SECTION 00 91 16

ADDENDUM NUMBER 7

- 1.01 DATE: APRIL 12, 2021
- 1.02 PROJECT: WELCOME CENTER
- 1.03 PROJECT NUMBER: DCM NO. 2020604
- 1.04 OWNER: ALABAMA A&M UNIVERSITY
- 1.05 ARCHITECT: NOLA | VAN PEURSEM ARCHITECTS, PC

4.04 SHEET S-2.3 – STRUCTURAL SCHEDULES:

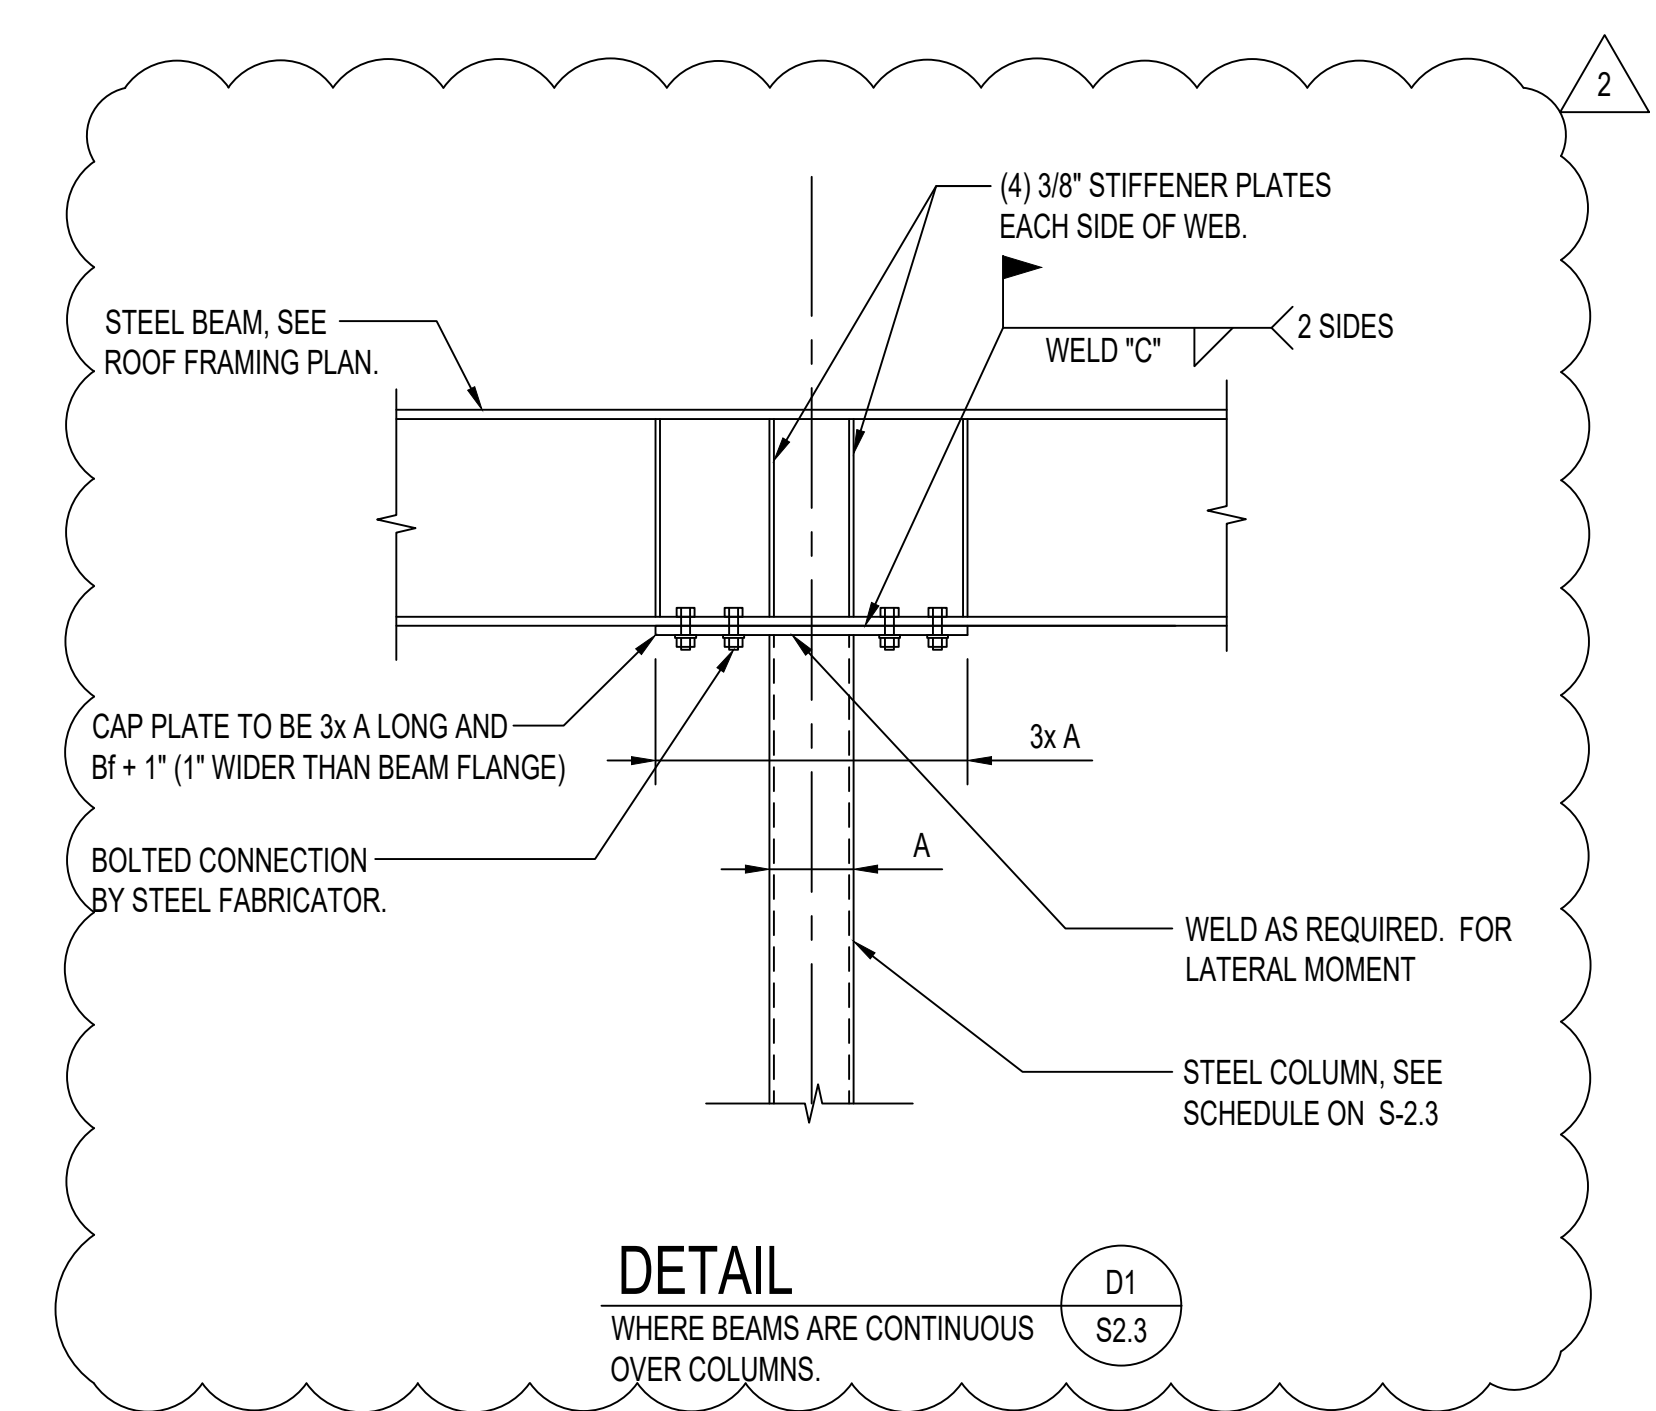
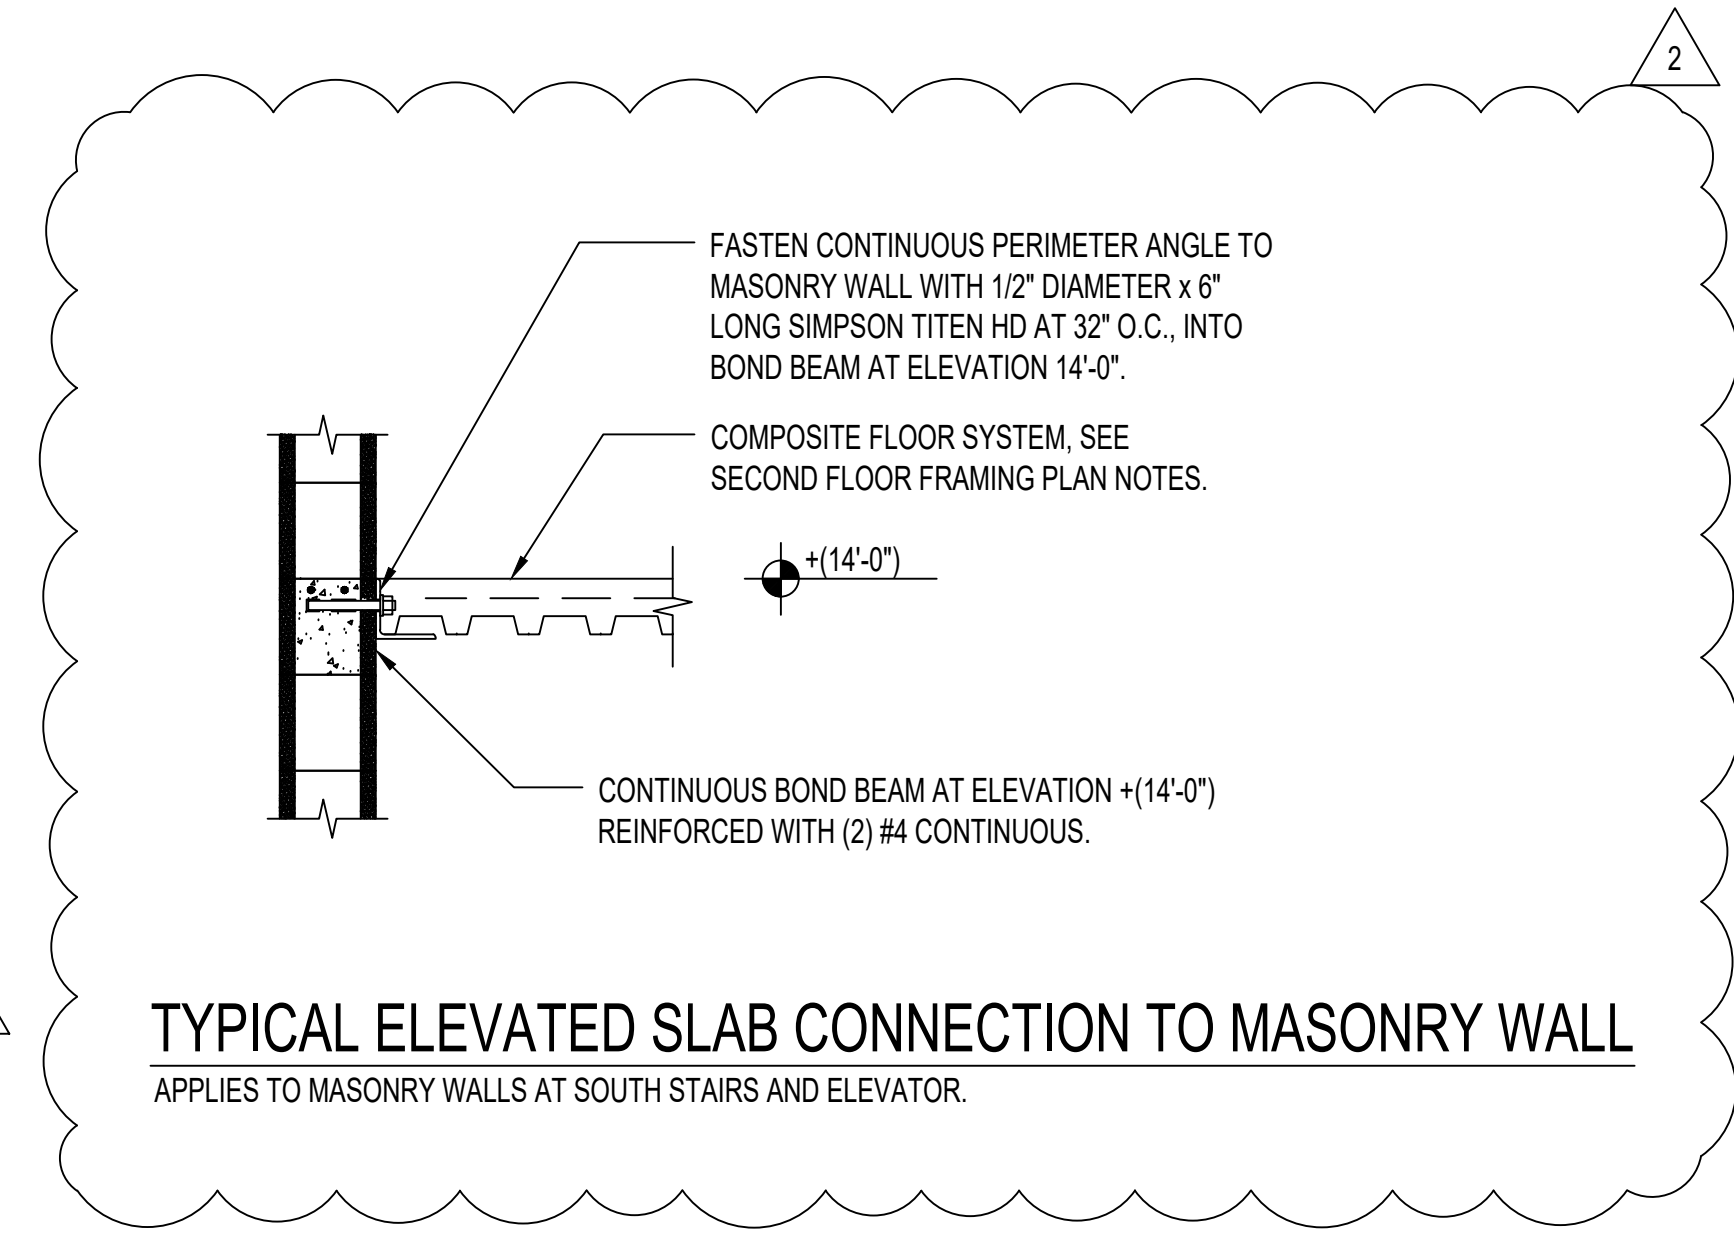
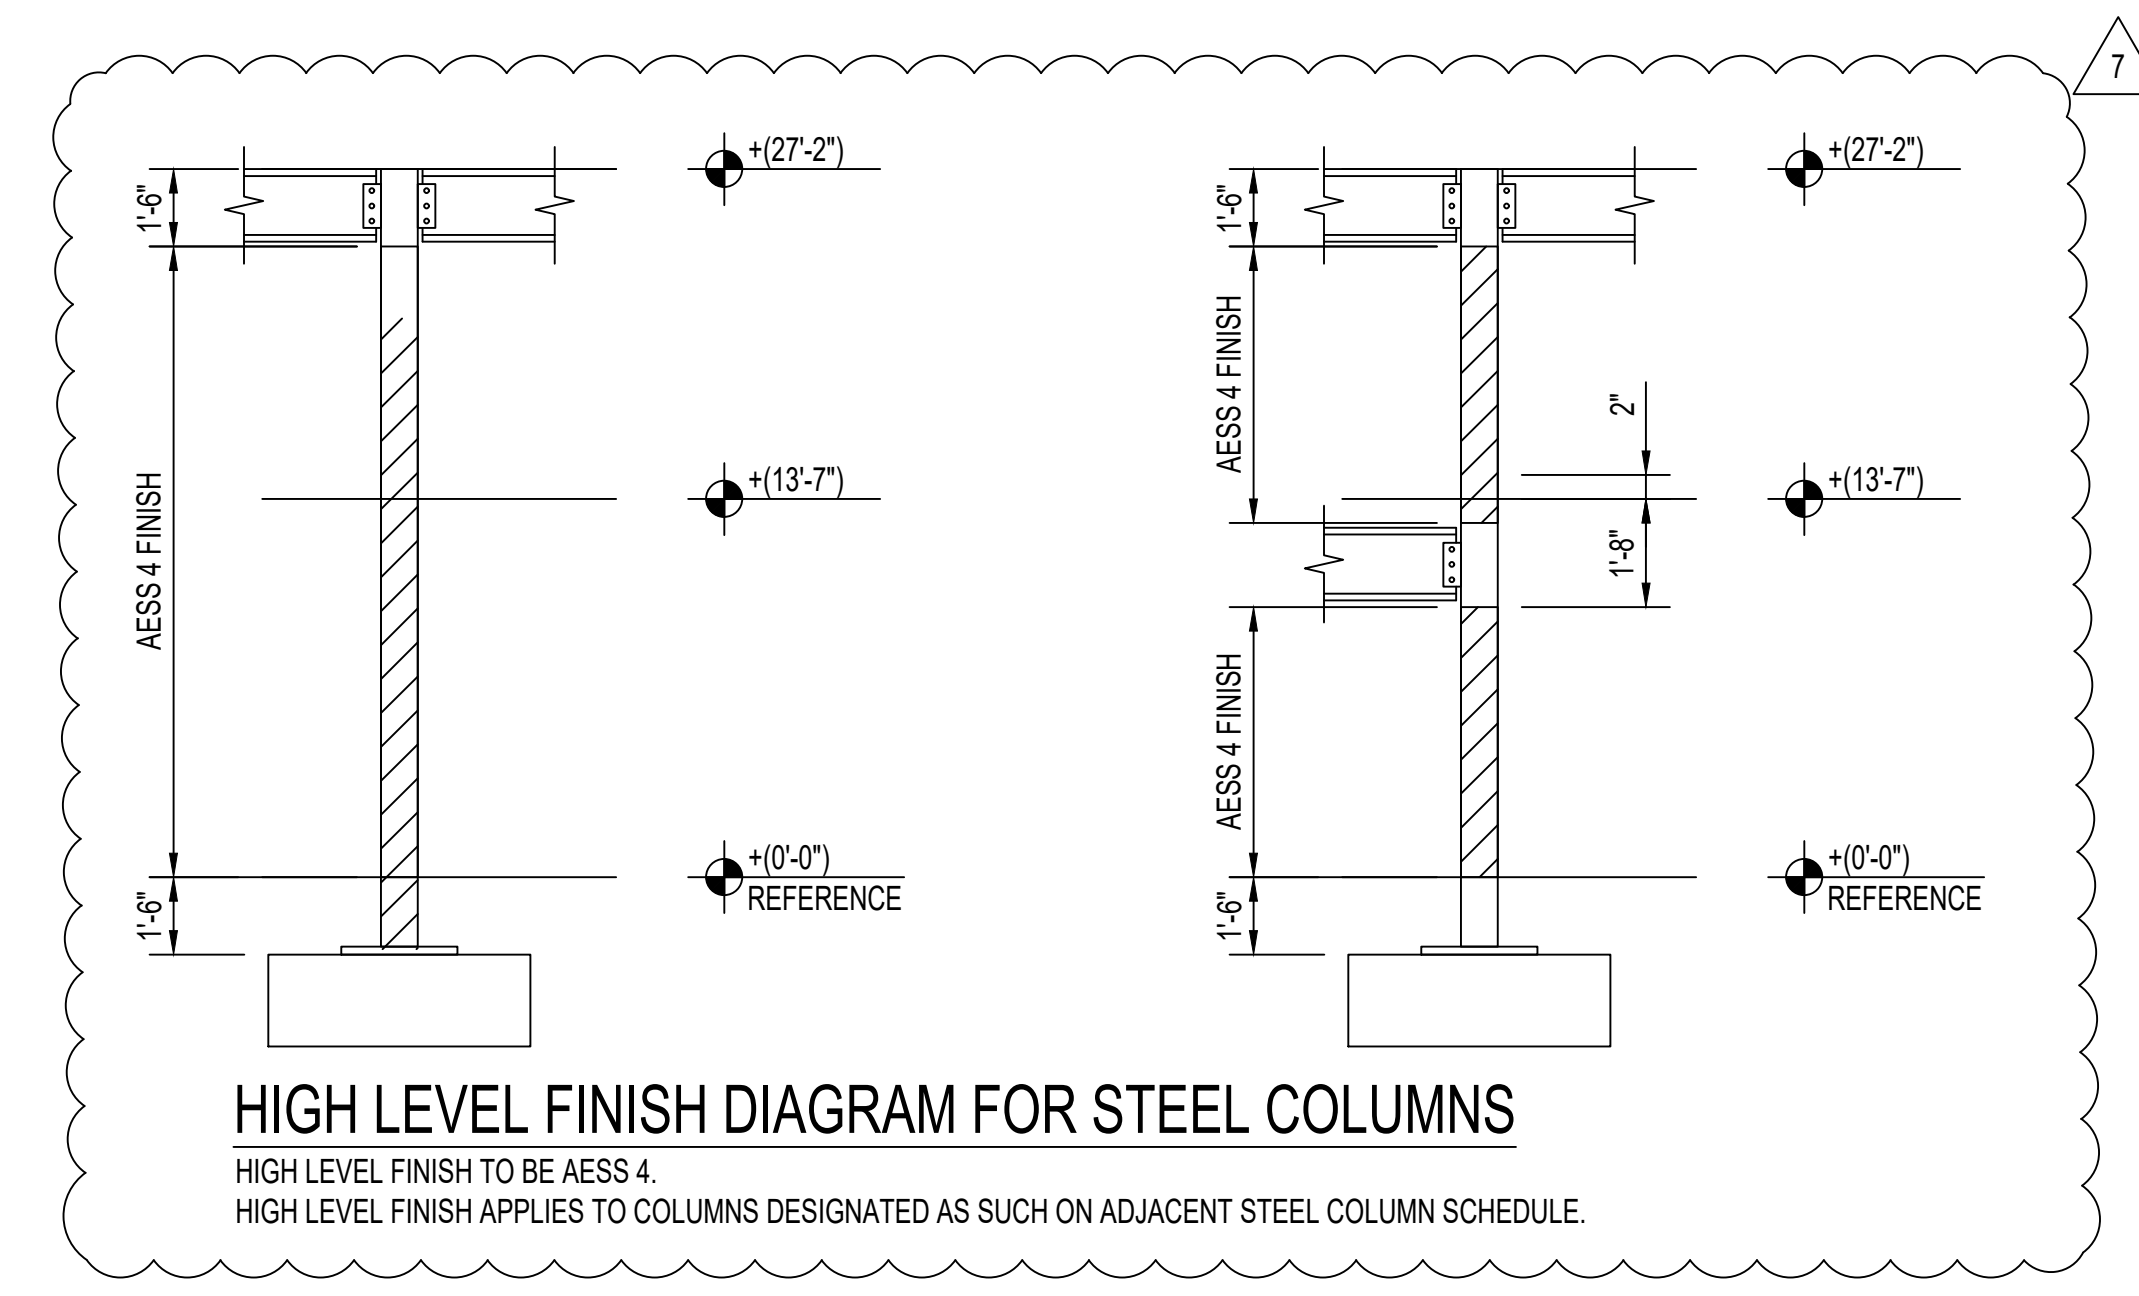
- A. Replace this Sheet in its Entirety. Revisions include the following:
1. Added wind beam data
 2. Revised columns with high level finish.
